Significant Further Information Response

Observation to An Coimisiún Pleanála

1. **Reserve Gas-Fired Generator (OCGT)** — ABP-320095-24 / (s.37E SID)
2. **Battery Energy Storage System (BESS)** — ABP-320916-24 (s.37 appeal, GCC ref 24/60845)
3. **400 kV Gas-Insulated Switchgear Substation (GIS)** — A07.320094 (s.182A SID)

One HGV traversing Killimor village (red line indicates stoppage)

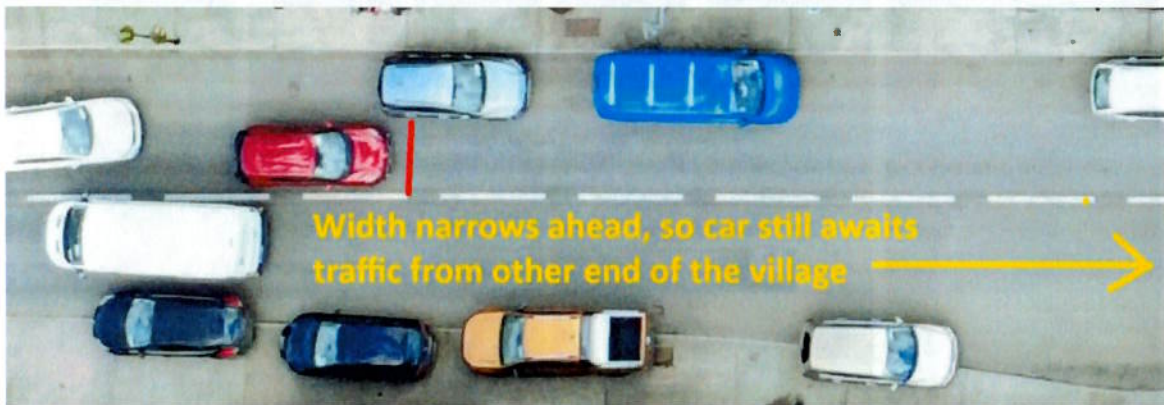
The applicant completely omits consideration of Killimor village, where collision data illustrates another concentration of collisions. There is a school to the immediate north of the village which accommodates approximately 150 students plus staff. The village itself is also a constraint on traffic flow in its own right: the route effectively narrows to a single lane through the village, presenting difficulty for ordinary traffic before any account is taken of the construction traffic that this development would route through it. This leaves a significant gap in its assessment route;

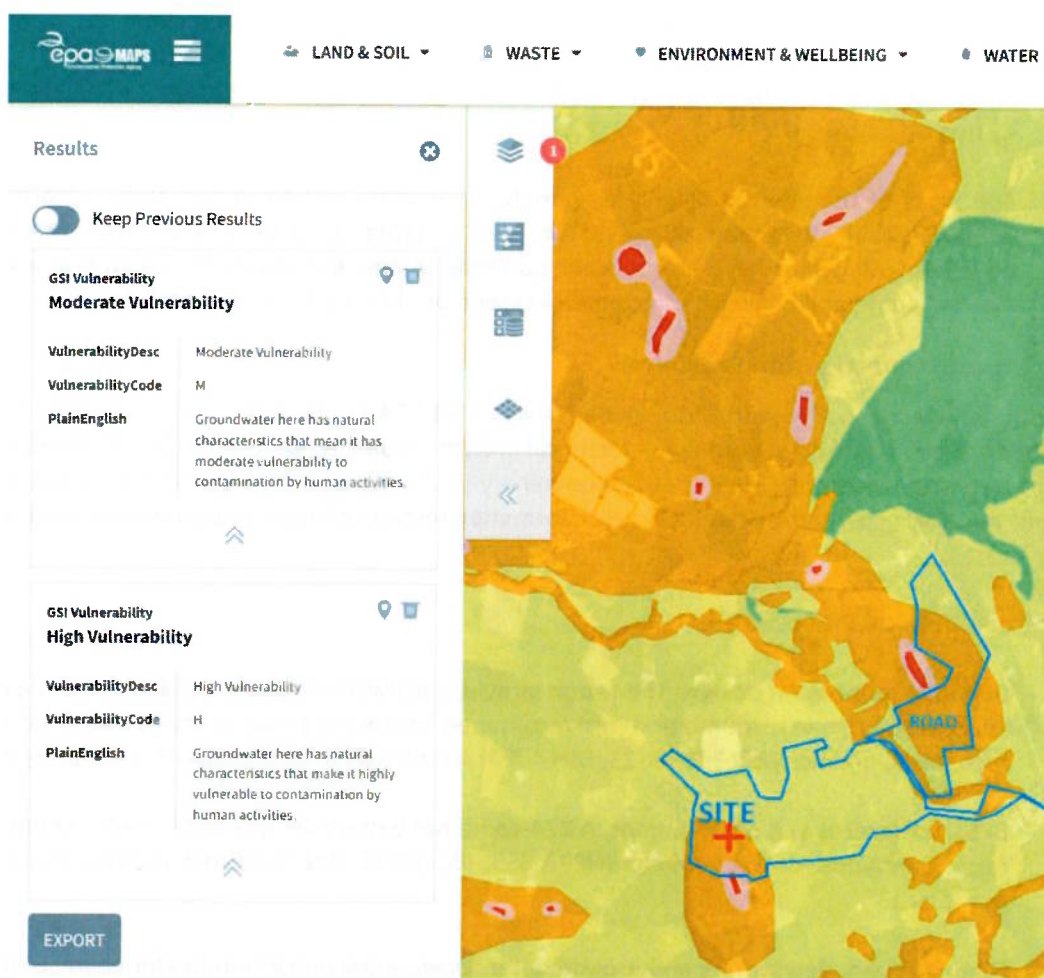
Instead of 7,647 HGVs for fill, we have calculated 33,707 HGVs (i.e. 67,414 movements) – 441% of the EIAR's fill estimation.

- i. the further 9,153 HGV's as deduced from EIAR calculations (for non-fill related matters), which we cannot assess without sufficient EIAR data.
- ii. HGV's for the proposed **new** access road construction, which remain undetermined according to addendum.

Figure 8.1 Catchment Map

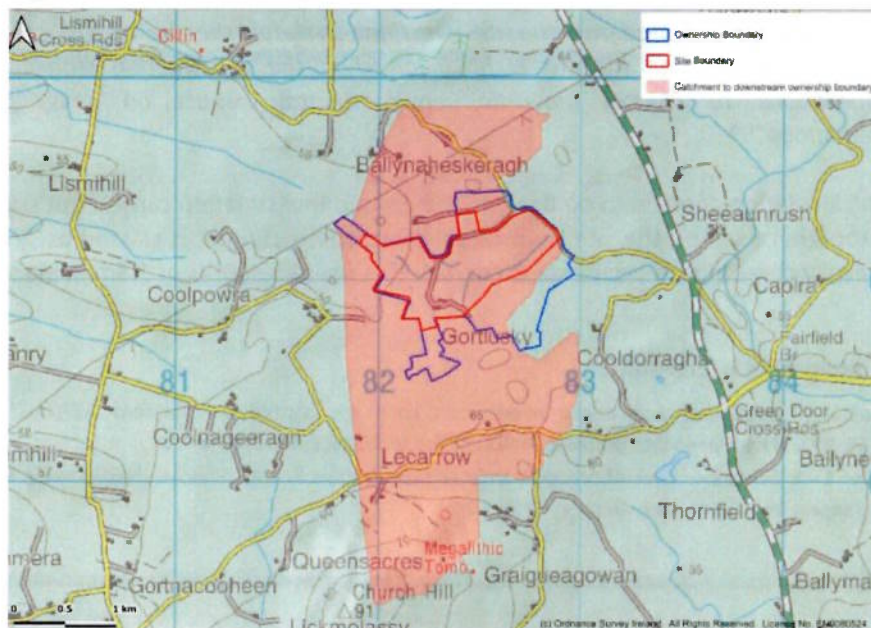
The site is a fluvial collection point for a significant area of surrounding land, including the higher ground at Church Hill to the south as shown in the 2024 EIAR;

As a result, the site and surrounding lands flood regularly (as the photographs show) in the winter. The photographs reflect the significant concerns of the surrounding landowners, whose local knowledge is that the watercourse carries far more water, and floods more often, than the EIAR presents. Those landowners are also concerned about what the proposed works would do to their own lands capacity to absorb rainfall, and whether the development would worsen the flooding they already experience.

Proposed Road Long section detailed on Drawing CPA-HAL-NR-XX-PL-3000. Proposed 6.59m increase to existing levels. There is approx. 2,580m³ of fill required in this small area alone. (112m long * 7m wide * 3.3m avg. depth). It is not accounted for in the addendum.

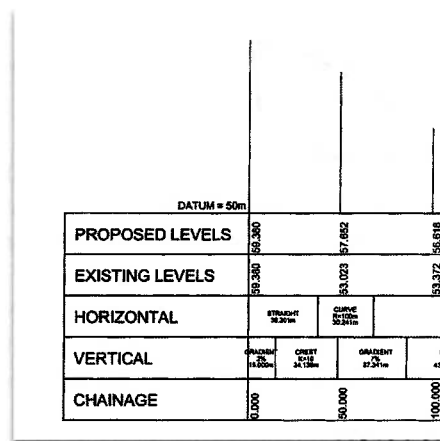
It is noteworthy that the cut & fill requirements of the proposed new access track have not been considered in this calculation. That proposed road has a footprint of approx. 7,763sqm (1,109m Long * 7m Wide). Drawing CPA-HAL-NR-XX-PL-3000 shows cuts of up to 2m being required and areas of fill of up to 6m of fill being required. This is a significant oversight in the cut & fill calculation. The road construction required is complex. Between chainage 700 and chainage 812, the proposed road will rise by 6.59m from existing ground levels. Between chainage 0 and chainage 50, the proposed road level will rise by 6.35m. This proposed road elevation rises to the top of a local esker which brings with it increased environmental considerations.

Proposed Road Long section detailed on Drawing CPA-HAL-NR-XX-PL-3000. Proposed 6.35m increase to existing levels. There is approx. 1,110m³ of fill required in this small area alone. (50m long * 7m wide * 3.18m avg. depth). It is not accounted for in the addendum.

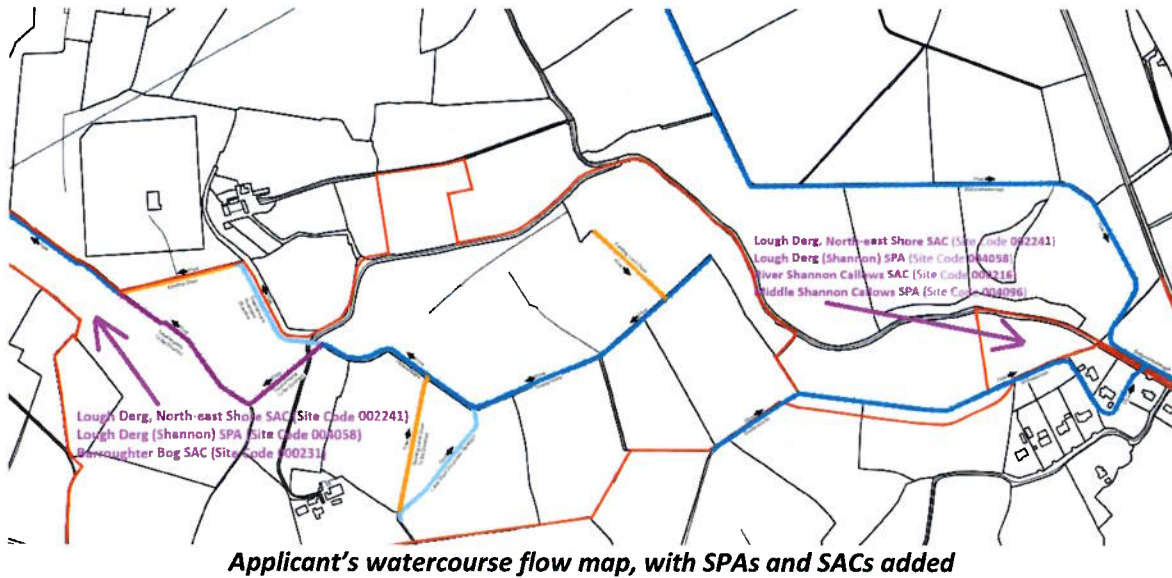
“Submit a suitably scaled drawing clearly identifying and labelling all existing watercourses and drainage ditches running from outside and through the site to include direction of flow. Figures 6.3 and 8.3 of the submitted EIAR and submitted layout drawings are considered insufficient in this regard”¹⁸³

While the developer has submitted a drawing in relation to above (CPA-HAL-MP-XX-DR-PL-10000), it is not sufficient. It is notable that the submitted drawing does not identify and include the details of the newly proposed site access road together with the watercourses. It also appears that multiple watercourses have been overlooked on the drawing. The developer has acknowledged at least two watercourses being affected by the newly proposed access road. Those watercourses are not identified on the drawing. The developer has therefore failed to provide the required information.

Developer's flow network drawing. Note: (EPA data indicates point C is the dividing line on western/eastern flow division, and that stream eventually continues northeast beneath esker ridge above "F").

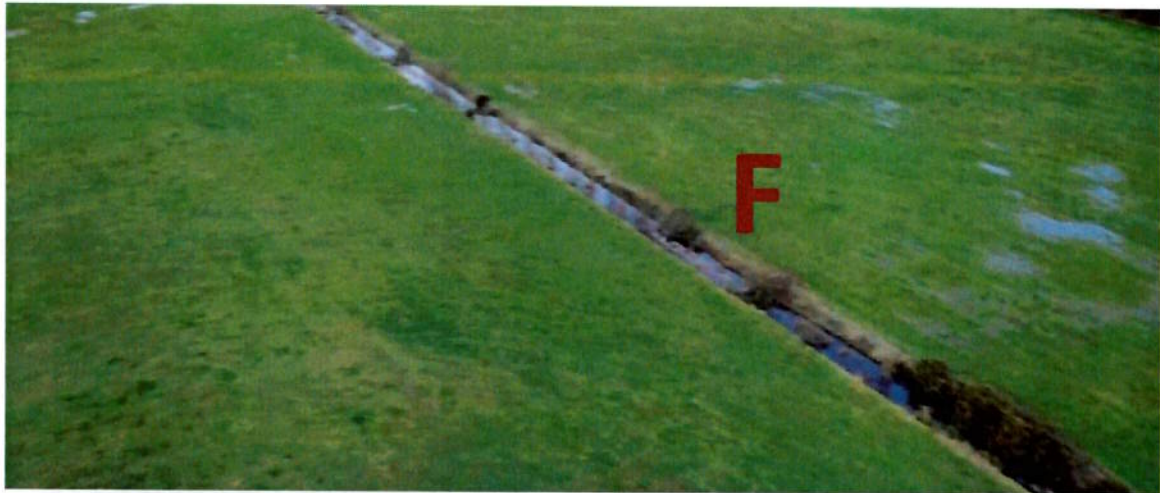
The connection to the Treananearla Stream, from the EirGrid site, as shown in photo B, is recent and has not been accounted for in the EIAR.

According to the applicant's map, it appears to acknowledge EirGrid's private drainage ditch as a completed stream channel to which it can adjoin. It's worth noting that EirGrid's intention was to **drain** its own site **into** the existing Treananearla stream – not for the drain to become the main artery for said stream.
